<b>Docket Number:</b>	00-AFC-14C
<b>Project Title:</b>	El Segundo Power Redevelopment Project Compliance
<b>TN #:</b>	200532
<b>Document Title:</b>	Applicant's Responses to Data Requests in Set Two (#84-90)
<b>Description:</b>	N/A
<b>Filer:</b>	Dee Hutchinson
<b>Organization:</b>	Locke Lord LLP
<b>Submitter Role:</b>	Applicant's Representative
<b>Submission Date:</b>	9/19/2013 4:01:13 PM
<b>Docketed Date:</b>	9/19/2013

Re: El Segundo Energy Center Petition to Amend (00-AFC-014C)  
Applicant's Responses to Data Requests in Set Two (#84-90)

Data Responses, Set 2  
(Response To Data Requests 84 to 90)

FIGURE DR88-1  
**Areas For Investigation or Identified Remediation**  
*El Segundo Energy Center*

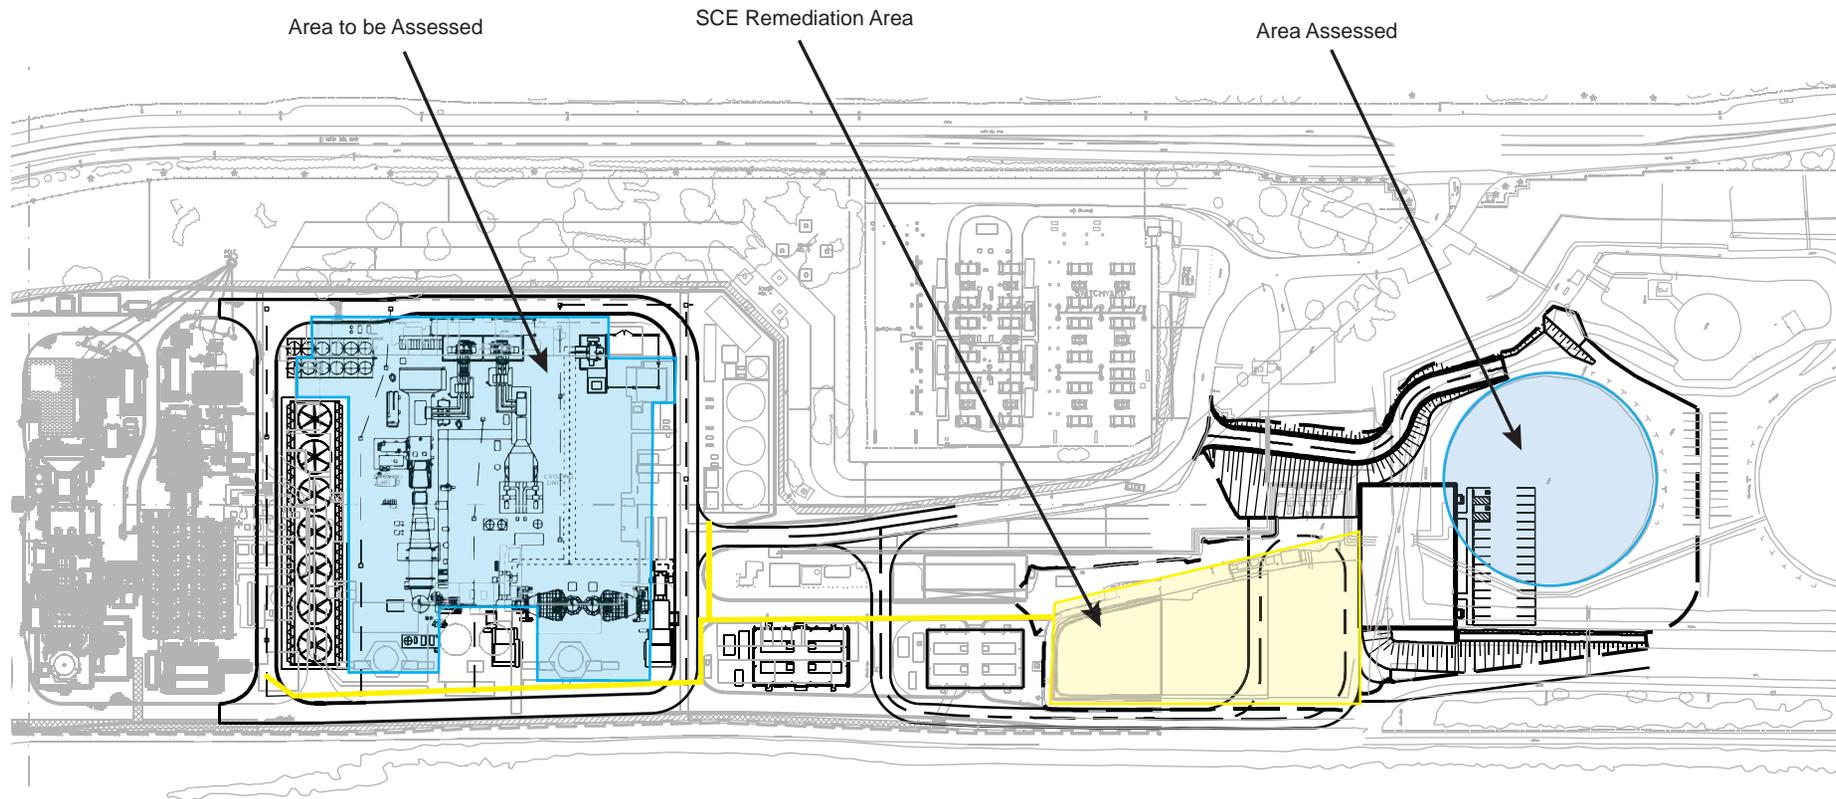
88. Please provide a map of contaminated areas on the site and where construction, demolition, or other disturbance may take place.

**Response:** Figure DR88-1 is a map of known contaminated areas onsite that will be addressed during construction of the new units.
